COMMISSION FOR HISTORICAL & ARCHITECTURAL PRESERVATION

STAFF REPORT

REQUEST: Retain Unapproved Exterior Work

ADDRESS: 1000 W. Lombard Street (Union Square Historic District)

Image 7: 1000 W. Lombard, June 2, 2018 – Left edge of ground floor window was to align with left edge of 2nd floor window above; right edge of new front door was to align with right edge of 2nd floor window directly above.

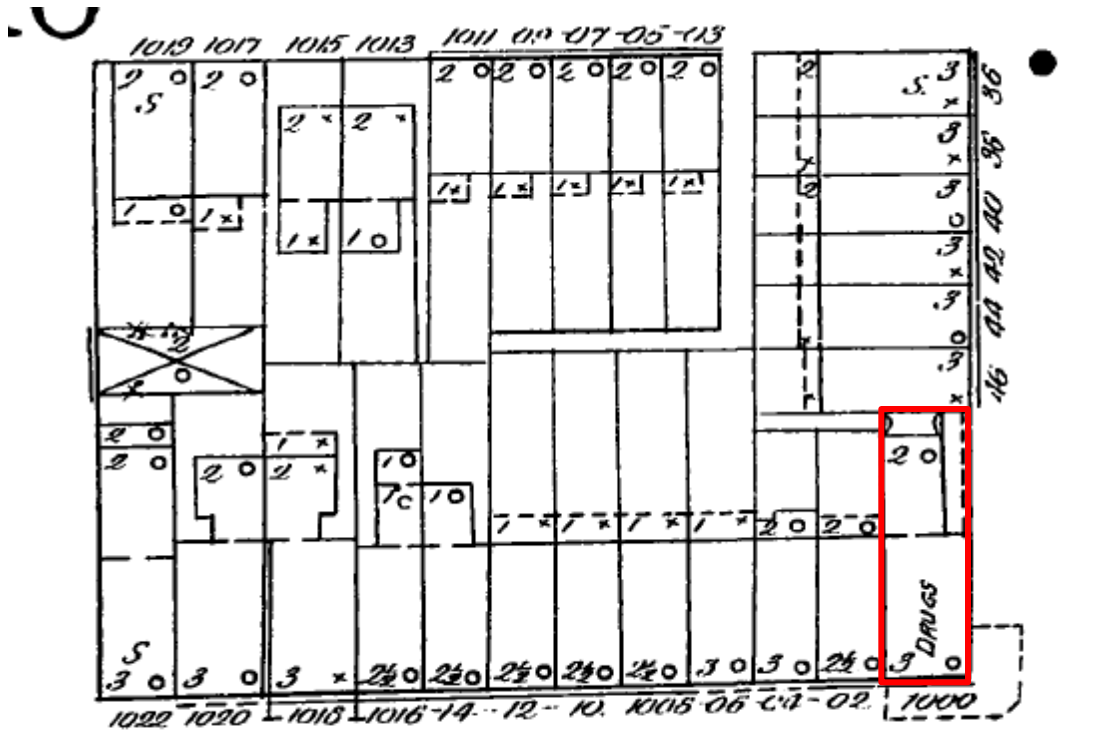
- A vinyl barrel awning with signage on the Lombard and Schroeder Street sides
- A metal roll-down door at the front entry
- A concrete ramp on a portion of the front sidewalk
- A window on the Schroeder Street side

- An awning over a door on the Schroeder Street side
- Blinking lights in windows

Furthermore, a hanging corner sign and support which was to be removed was retained and signage added for the new business.

- **CHAP staff recommends a finding of disapproval of the request to retain the exterior work performed without CHAP approval, and which does not meet CHAP design guidelines.**
- **The owner should work with staff to remove the unapproved alterations as soon as possible and make corrections that conform to the October 27, 2016, Authorization to Proceed.**

Image 6: Approved plan, with mark-ups by CHAP staff, October 26, 2016.

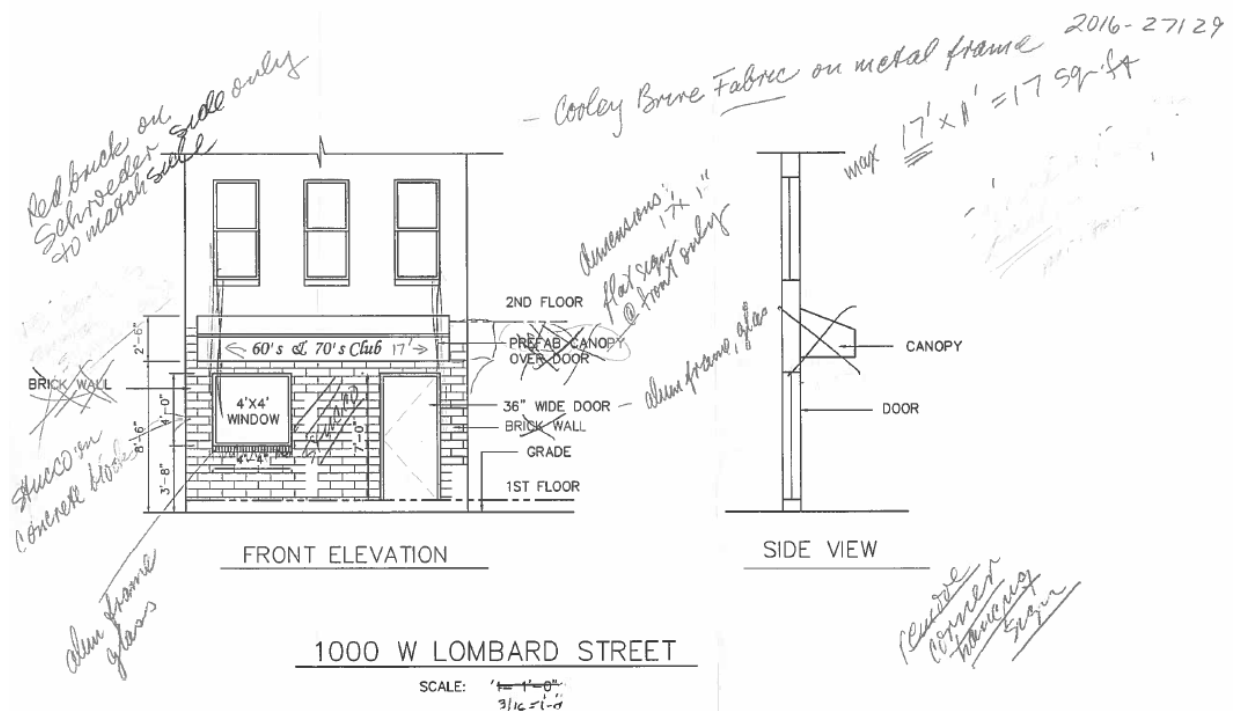
- October 25, 2016—CHAP staff, Walter Gallas, visited the site.
- October 27, 2016 –After the site visit, and after discussing the proposed plan with the applicant and CHAP director Eric Holcomb, and making notes on the plans while meeting with Mr. Mirze, Gallas wrote an Authorization to Proceed. Among the items approved in the ATP: a flat unlit sign of maximum dimension of 17’-0” by 1’-0” attached in the space between the 1st and 2nd floors on the Lombard Street side and removal of the corner hanging sign and supports. *No awning of any kind was approved, neither was an ADA ramp, a roll-down door, a window on the Schroeder Street side nor an awning over the Schroeder Street doorway.*

There were no historic materials or detailing in the entryway, and the most recent door was a metal door with small pane of glass. Therefore, staff permitted relocation of the opening with an aluminum frame glass door, provided that the right edge of the door aligned with the right edge of the second floor window above. These conditions were stated in the Authorization to Proceed. A metal roll-down door is not appropriate to a historic building of this type on a principal façade. It is an industrial feature and was not approved.

As with the entryway, staff determined that there was no historic fabric remaining at the windowless first floor on the primary facade, and therefore approved the installation of a single-pane aluminum frame window at the left, provided that the left edge of the window align with the left edge of the second floor window above. These conditions were stated in the Authorization to Proceed. While the doorway seems to come close to aligning with the right edge of the second floor window, the window on the front is not installed to align with the left hand edge of the second floor window. Staff did not approve a rectangular single-pane glass window which was installed at the Schroeder Street side, just around the corner from the entry door.

The approved signage was to consist of a flat sign on the front band (fascia) above the first floor, a remnant of the storefront. The sign was to be a fabric stretched on a metal frame with a maximum size of 17 feet by 1 foot, and not lit. In addition, the existing corner hanging sign from a previous business was to be removed along with the sign supports. An awning was not approved. Contrary to the Authorization to Proceed, a barrel awning wrapping the building at the Lombard and Schroeder corner and containing signage was installed. Also, contrary to the Authorization to Proceed, the corner hanging sign was not removed. Instead, this sign was retained and altered to advertise the current business. Staff did not approve an awning which was installed over a door on the Schroeder Street side.
